**Report to the Future Melbourne (Planning) Committee**

**Ministerial Referral: ID-2016-3 (Amendment GC44)  
Melbourne Convention and Exhibition Centre  
2-26 Clarendon Street, South Wharf**

### MINISTERIAL REFERRAL

<b>Application number:</b>	<b>ID-2016-3</b>
<b>DELWP Application number:</b>	<b>MBR029290 - Amendment GC44</b>
<b>Applicant / Owner / Architect:</b>	Urbis Pty Ltd / Plenary Group Pty Ltd / NH Architecture and Woods Bagot
<b>Address:</b>	Melbourne Convention Exhibition Centre, 2-26 Clarendon Street, SOUTH WHARF VIC 3006
<b>Proposal:</b>	Stage 2 of Melbourne Convention and Exhibition Centre - expansion of convention centre, new hotel and carpark
<b>Date received by Melbourne City Council:</b>	14 April 2016
<b>Responsible officer:</b>	Kate Yuncken
<b>Report Date:</b>	28 April 2016

PREVIOUS PROPOSAL PEDESTRIAN LINK

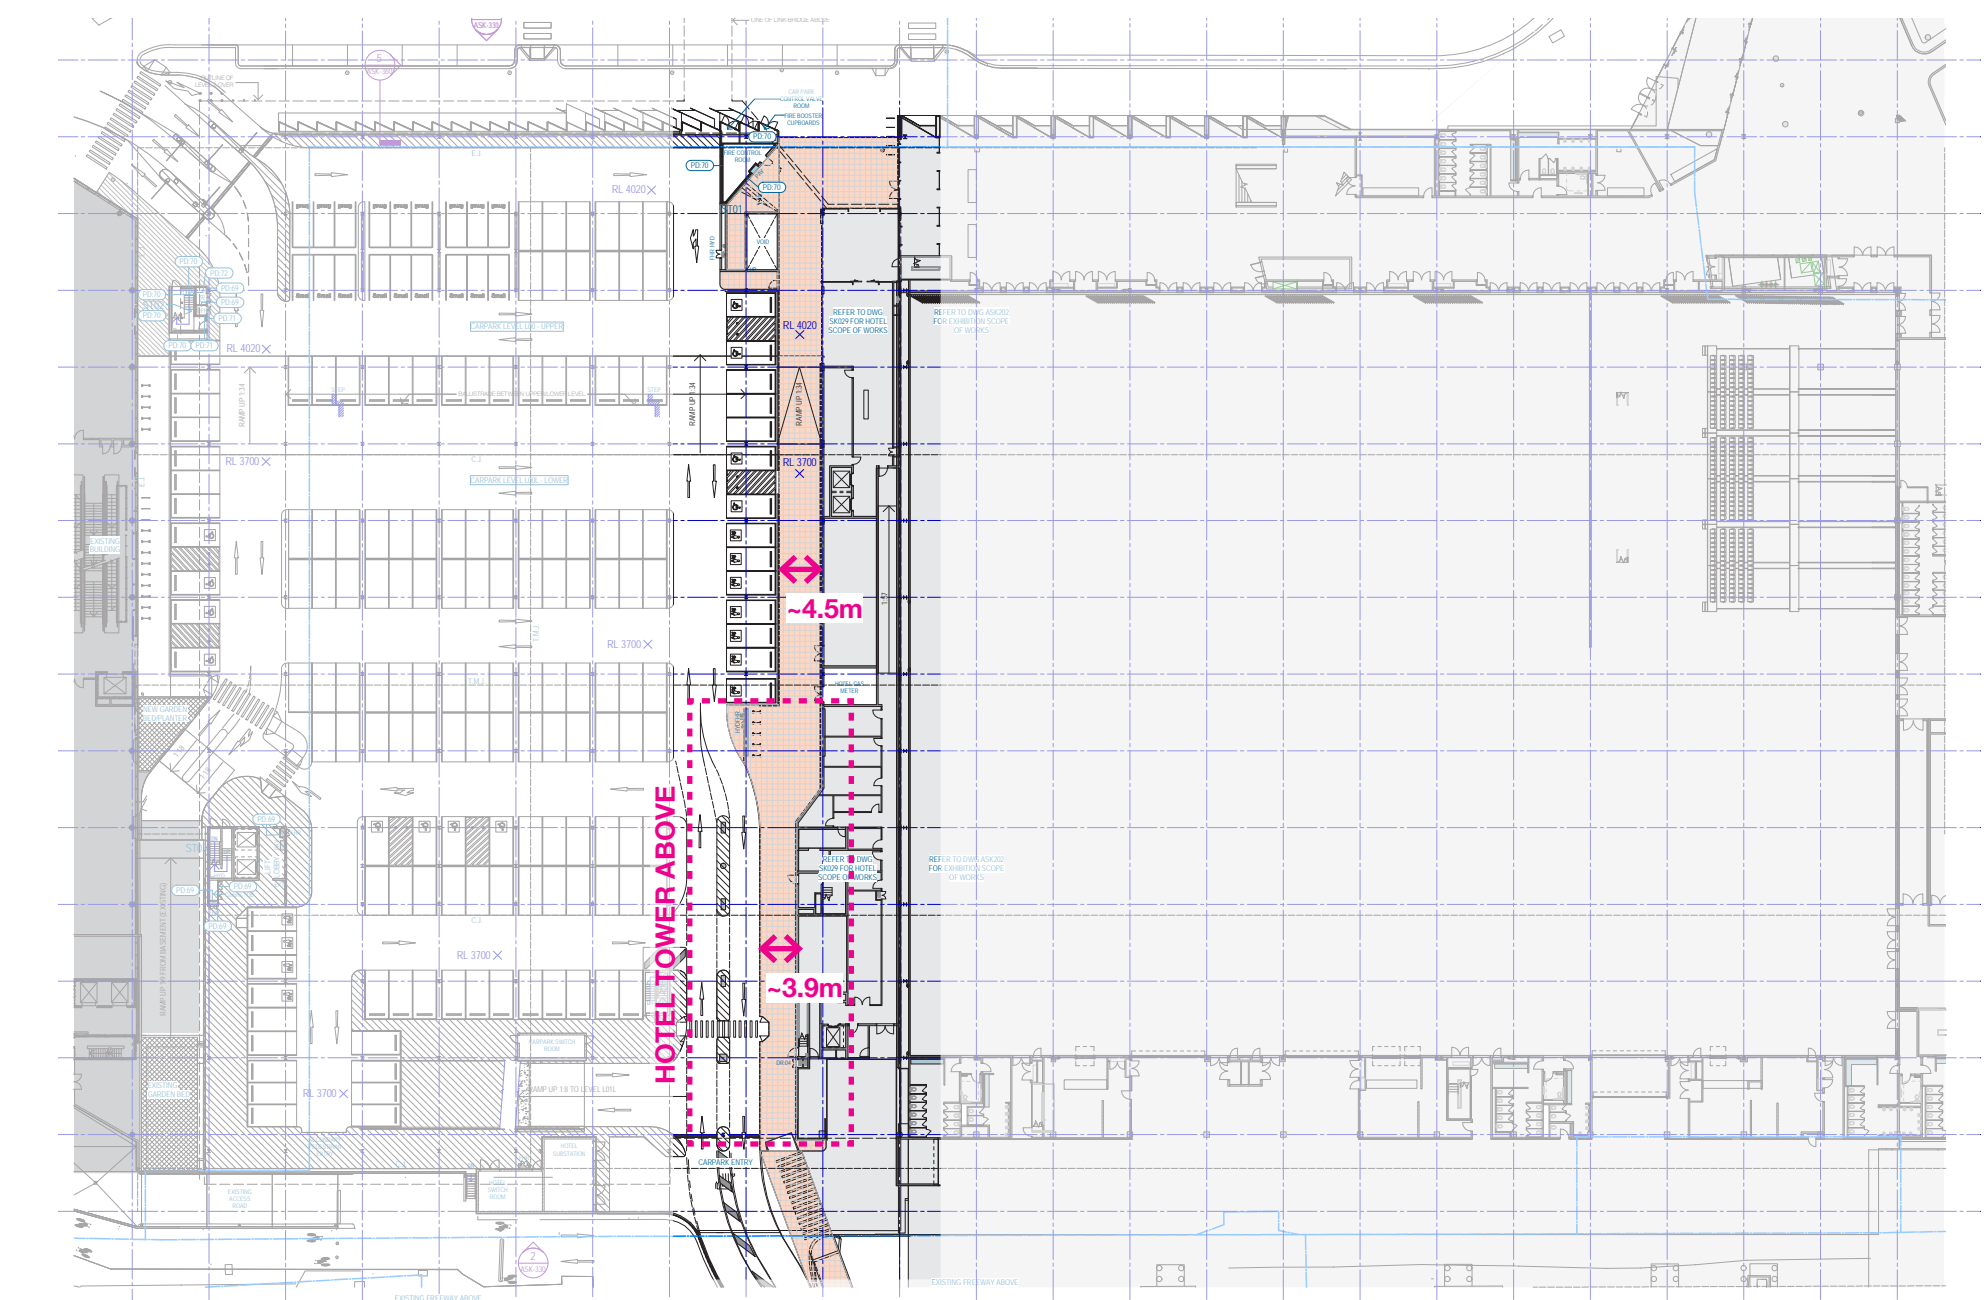
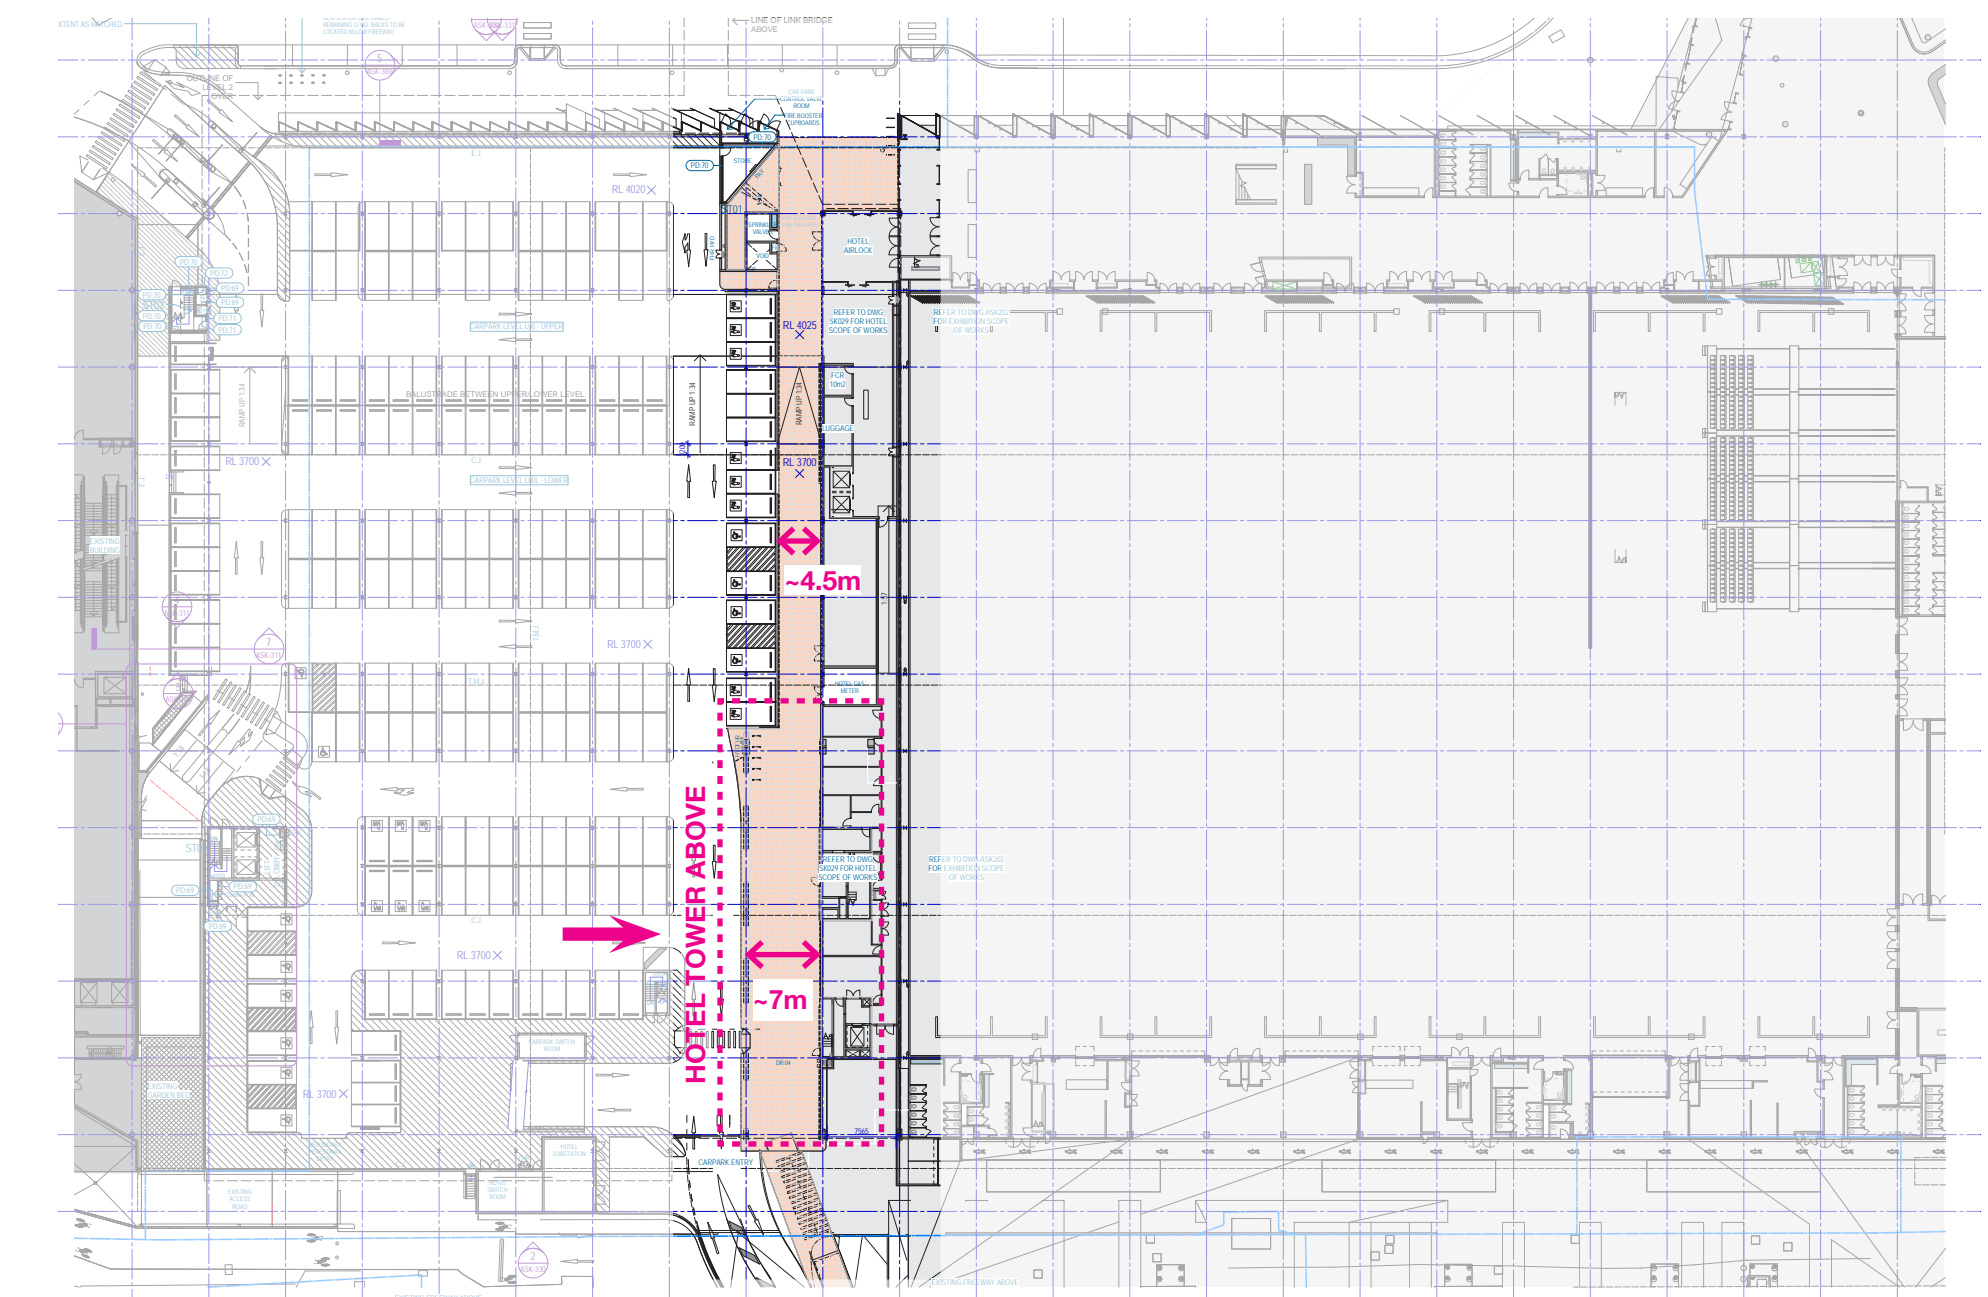
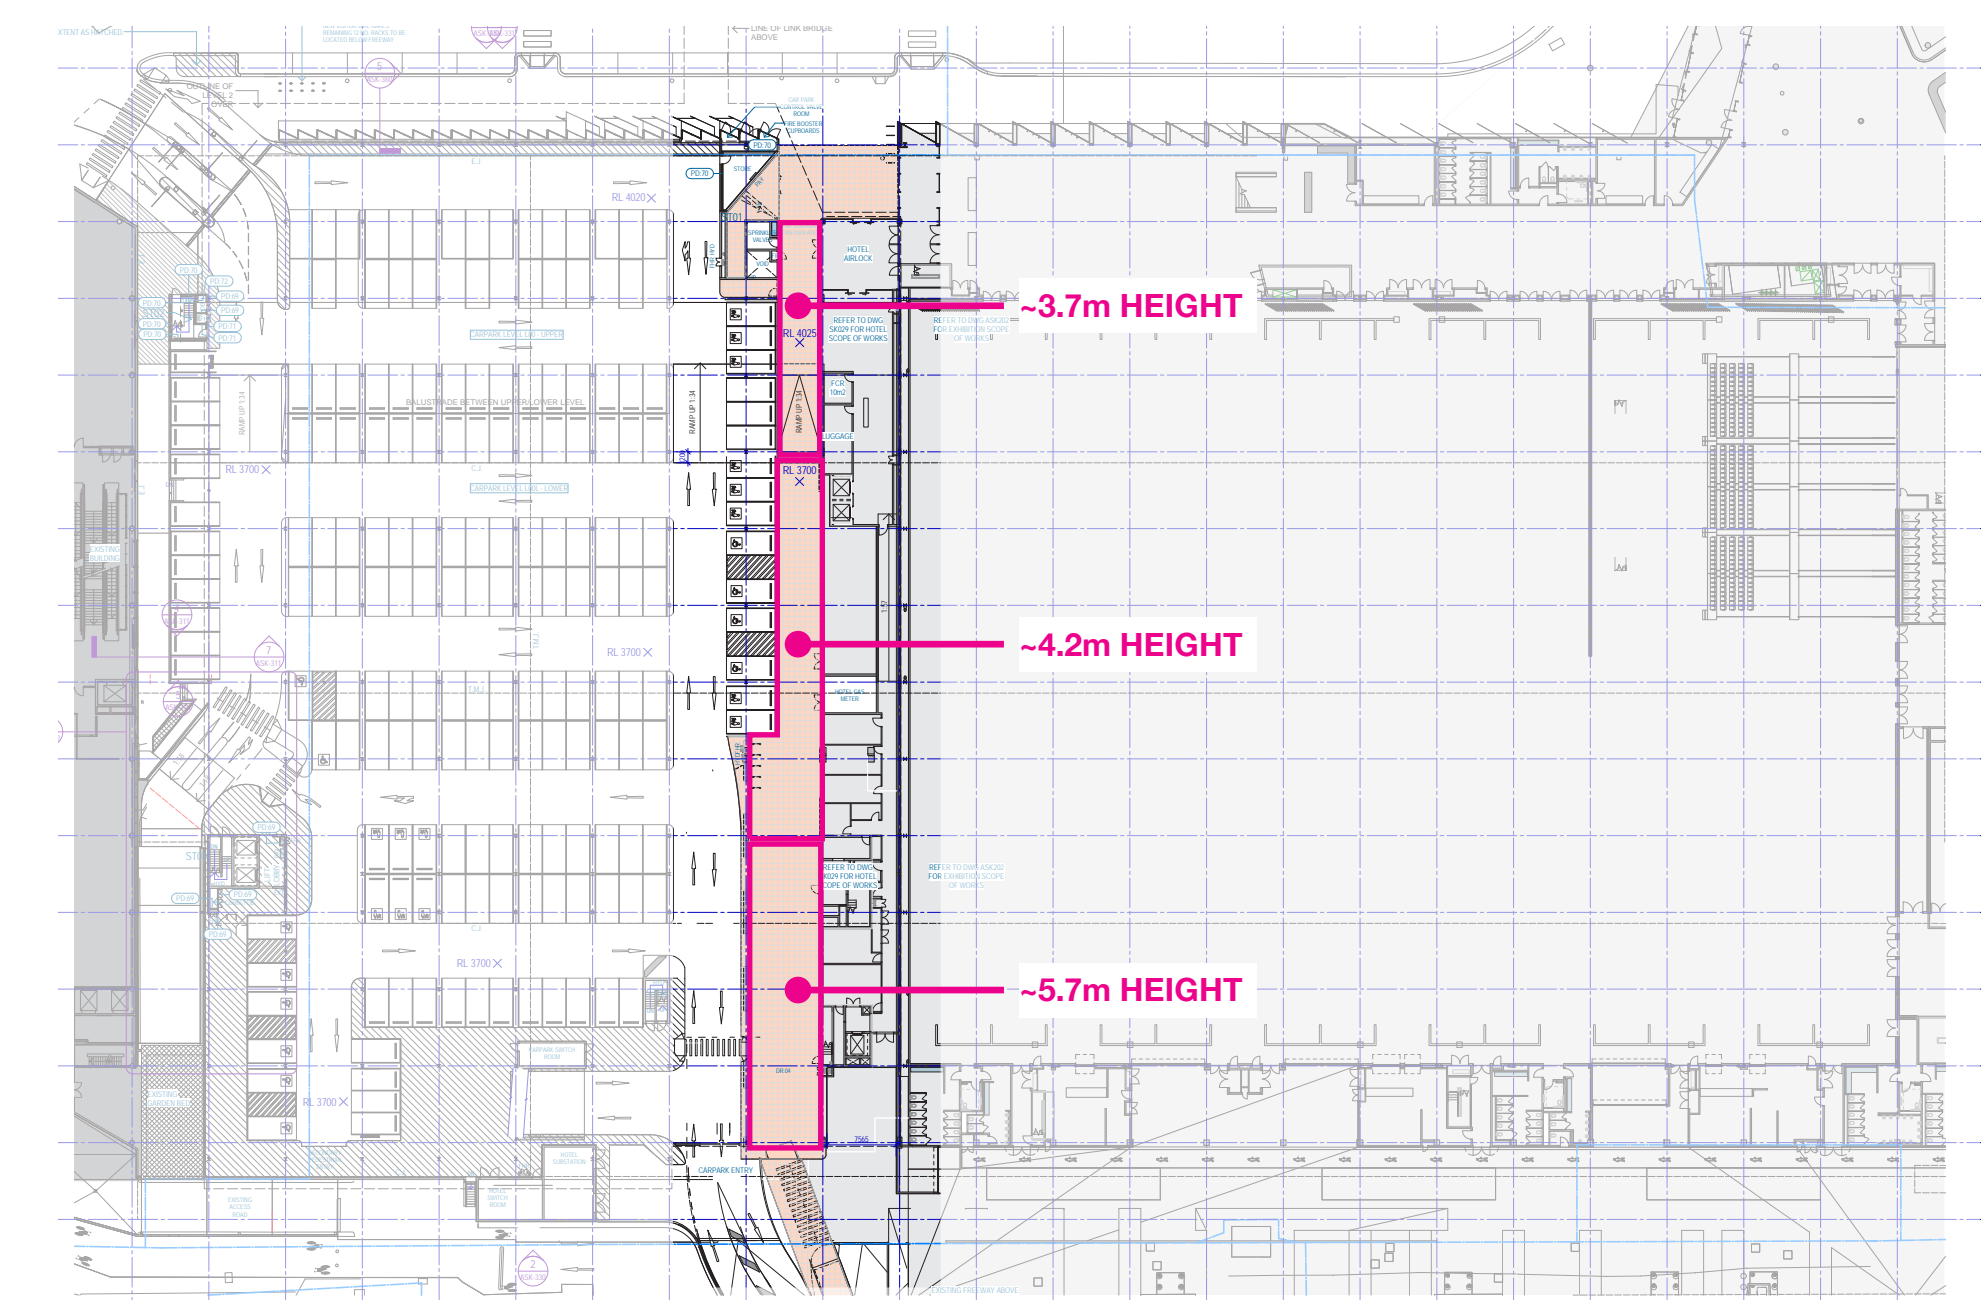
Several concerns have been raised by both the Urban Design and City Design team in regard to the north-south ground level pedestrian link that is bounded by the Exhibition Hall and Hotel on one side and the new multi-storey car park on the other. Concerns of safety, narrowness of the link, blind spots (poor sightlines) and attractiveness were raised and passed onto the applicant.

- The through block link has been widened to 7 metres and the ceiling heights have been increased to provide heights ranging from 3.7 metres to 5.5 metres.
- The detailing of the northern and southern entries to the link have been enhanced to create generous portals highlighting the entry points.
- The hotel has been moved 1.6 m further to the east to enable the provision of a straight link through the building.
